# Technical Consultation of the Hubble Space Telescope (HST) Nickel Hydrogen (NiH<sub>2</sub>) Battery Charge Capacity Prediction

**NASA Engineering and Safety Center  
Consultation Position Paper**

A multi-Center and industry review team of knowledgeable Nickel Hydrogen (NiH<sub>2</sub>) battery specialists was convened to assess the Goddard Space Flight Center (GSFC) position paper entitled, "The State of the HST Batteries as it Relates to HST Health, Safety, and Ability to Support an On-going Science Operation", dated May 21, 2004 (provided in Appendix D) [ref. 1]. This document was prepared by Dr. J. Keith Kalinowski, Deputy Manager, Hubble Space Telescope (HST) Operations Project, with planned approval by Preston M. Burch, Manager, HST Program Office. The document review was supplemented with extensive technical discussions with the position paper author, pertinent reports from literature, NASA-sponsored Aerospace Battery Workshops, and consultations with team peers.

**Figure 2.3-1. Typical Plot of Correlation between Battery Voltage (at 9 Ah load) and Cell Capacity at 1.2 V**

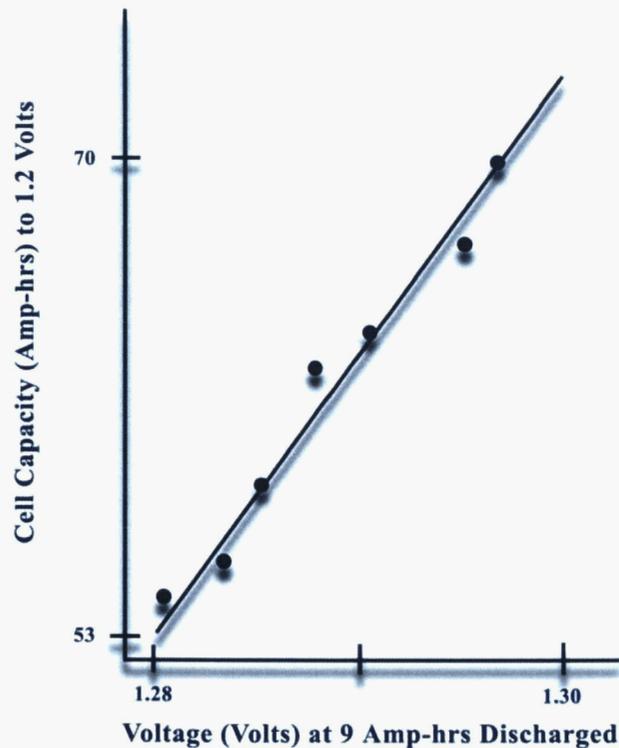
- 2.3. Determine if a proportional correlation exists between the voltages in the test battery discharge at the 9 Ah point and the measured capacity to 1.2 V for each cell (Figure 2.3-1).

*Correlations between NiH<sub>2</sub> cell or battery voltage and the amount of stored capacity have often been found to be confounded by all the other variables that influence voltage, but not capacity. Such variables include current, temperature, and the past history of charge, discharge, as well as the SOC.*

*Discussions concerning the FSB testing, where the voltages of all cells are measured, have sometimes equated cell voltage divergence during cycling to capacity divergence. Establishing a correlation between the amount of stored capacity and the cell voltage at the end of the 9 to 10% DOD orbital cycle would provide a simple, real-time diagnostic tool to monitor the evolution of cell imbalance during cycling. This correlation could be checked (or recalibrated) each time the test battery is subjected to a capacity test. Such a correlation would plot the voltage of each cell at the DOD corresponding to orbital cycling (~10% DOD) during the capacity discharge against the capacity measured for that cell to 1.2 V. If a good correlation is in fact found to exist, cell voltage dispersion at the end of each orbital cycle can be used to accurately indicate relative shifts in cell capacities, and thus capacity imbalance. If a good correlation is not established, cell voltage divergence should not necessarily be used as a meaningful measure of capacity imbalance.*

*For HST batteries, where individual cell voltages are not available, this tool may help quantify how shifts in battery voltage during eclipse operation or capacity testing could translate into capacity loss or capacity divergence.*

Figure 3.3-1. Ratchet Charging for Nominal On-orbit Cycling Operations

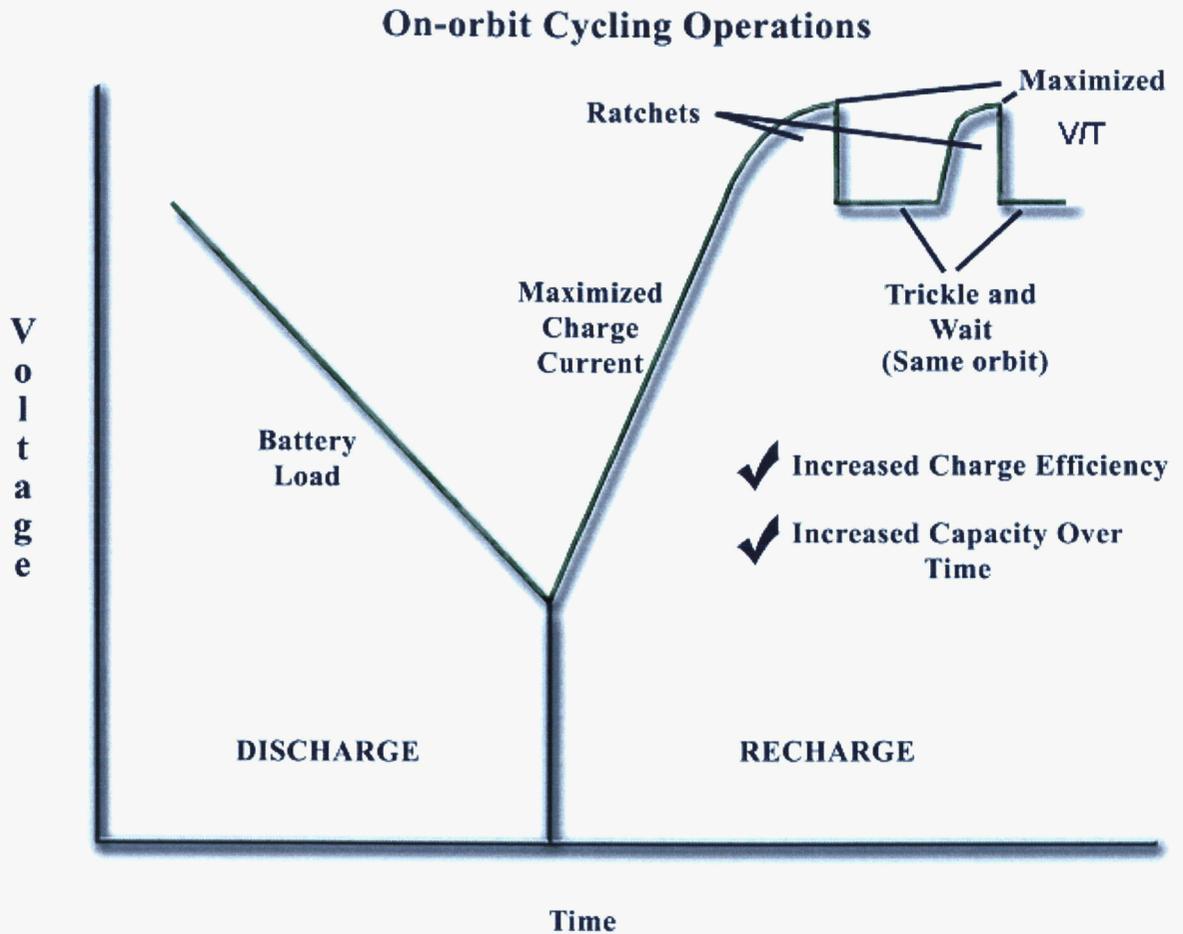
- On-orbital cycling operations (Figure 3.3-1)
- Ratchet charging following capacity check (Figure 3.3-2)

*Ratchet charging involves recharge to a V/T level or other charge cutoff criterion at a high charge rate, followed by a period of rest (typically trickle charge or open circuit), then a repeated recharge at the high rate to the same V/T cutoff level. If time permits, this high rate recharge and rest period can be repeated multiple times to ratchet the state of charge to higher levels (in LEO there may only be time for one ratchet). The overall RCF is intended to be similar to that with no ratchet recharge. However, three factors provide higher charge efficiency with the ratchet pulse-recharge sequence when the peak recharge rate is maximized. First, the lower recharge voltage that results from the rest period provides improved charge efficiency. Second, the trickle charge is more efficient when performed at a lower average state of charge. Third, charge efficiency always tends to be greater at higher recharge current.*

*This charge control method is particularly advantageous when recharge to the V/T cutoff at high rate occurs in a short period of time. Application of much of the trickle charge during the middle portion of the recharge period takes maximum advantage of the higher charge efficiency for trickle charge at lower SOC. The second high rate recharge pulse will provide an SOC boost due to the improved charge efficiency at the high recharge rate. Repeated recharge pulses with adequate rest between can ratchet the SOC up significantly.*
